Manual Supplement

Manual Title: 116C Users
Part Number: 2538707
Print Date: July 2006
Revision/Date:

Supplement Issue: **3**
Issue Date: 9/06
Page Count: 3

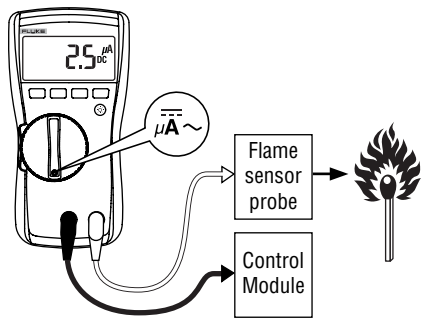
On page 13, replace the figure with the following:
